RESPONSE TO REQUEST FOR ADDITIONAL INFORMATION

APR1400 Design Certification

Docket No. 52-046

RAI No.: 155-8167
SRP Section: 06.02.05 – Combustible Gas Control in Containment
Application Section: 6.2.5
Date of RAI Issue: 08/18/2015

Figure 6.2.5-1 Containment Hydrogen Control System

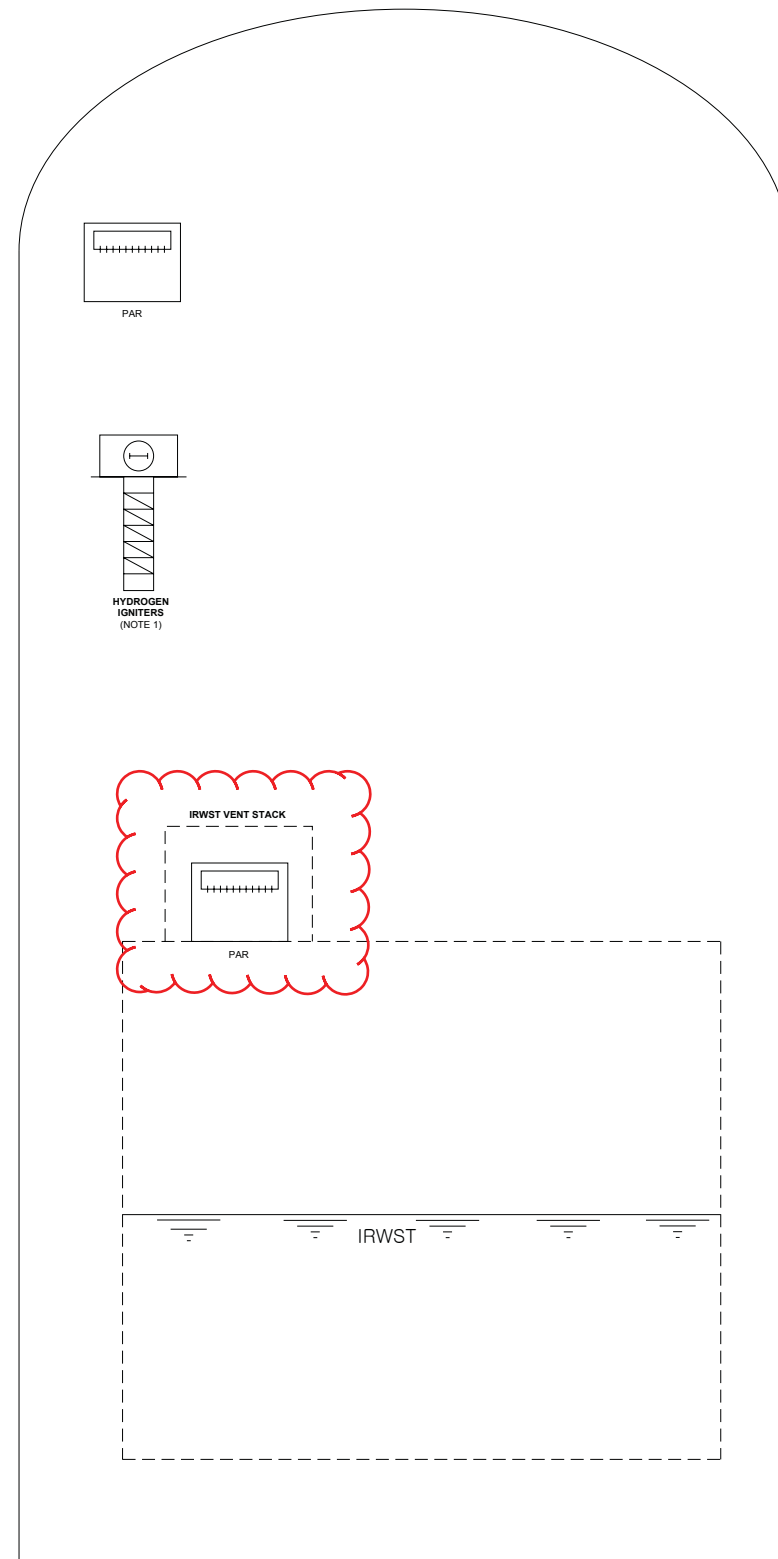
- Tier 2, Section 6.2.5.2.1 describes PAR(s) inside the IRWST.
- Tier 2, Table 6.2.5-1 identifies 4 PARs at the IRWST vent stack area.
- Tier 2, Figure 19.2.3-1 and Tables 19.2.3-1 and 19.2.3-2 indicate that 4 PARs are inside the IRWST.
- Tier 2, Figure 6.2.5-1 shows the PARs outside and above the IRWST.

Please clarify the location of the PARs with respect to the IRWST and revise all the affected DCD text, tables, and figures accordingly.

Subsection 6.2.5.2.1, 6.8.2.2.5, Table 6.2.5-1, and Table 19.2.3-1 in DCD Tier 2 will be revised to indicate the PARs are located “inside the IRWST vent stack”, and the PARs location in Figure 2.11.4-1 and Figure 19.2.3-1 will be revised from the IRWST to inside the IRWST vent stack, as indicated in Attachment 2 of this response. In addition, the IRWST vent stack will be added to Figure 6.2.5-1.

In DCD Tier 2, Subsection 6.2.5.2.1 and 6.8.2.2.5, Table 6.2.5-1 and 19.2.3-1, Figure 2.11.4-1, 6.2.5-1 and 19.2.3-1 will be revised as indicated in Attachment 2 of this response.
